Re: Proposed Tullamore Industrial Development 6086, 6186, 6026, 6230 Mayfield & 12151 Airport Road Town of Caledon, Regional Municipality of Peel Traffic Addendum Letter

2.0 THE TOWN OF CALEDON COMMENTS, TRANSPORTATION (JULY 12, 2024)

3.0 THE REGIONAL MUNICIPALITY OF PEEL COMMENTS, TRAFFIC DEVELOPMENT (JULY 29, 2024)

Figure 2 Right-in/Right-out Access and Mayfield Road intersection Conceptual Design

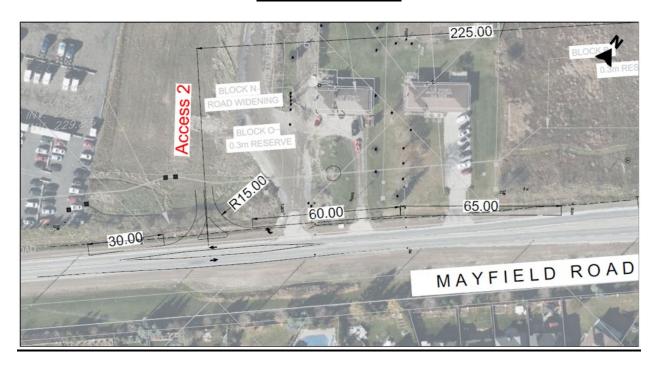
The new right-in/right-out access onto Mayfield Road will require an auxiliary right turn lane, which shall meet minimum TAC standards. Spacing from other intersections to be shown on Site Plan.

If the right-in/right-out access is approved, it will need to be physically restricted by a centre median.

Acknowledged. The conceptual design of the right-in/right-out access onto Mayfield Road is shown in **Figure 2**, with the overall layout plan provided in **Appendix C**. The design includes an auxiliary right-turn lane into the site, and the intersection spacing complies with the Region's spacing requirements.

Acknowledged. The conceptual design includes a median to restrict southbound and eastbound left-turn movements. These provisions will be included in the subdivision agreement, which will be executed by the parties prior to plan registration.
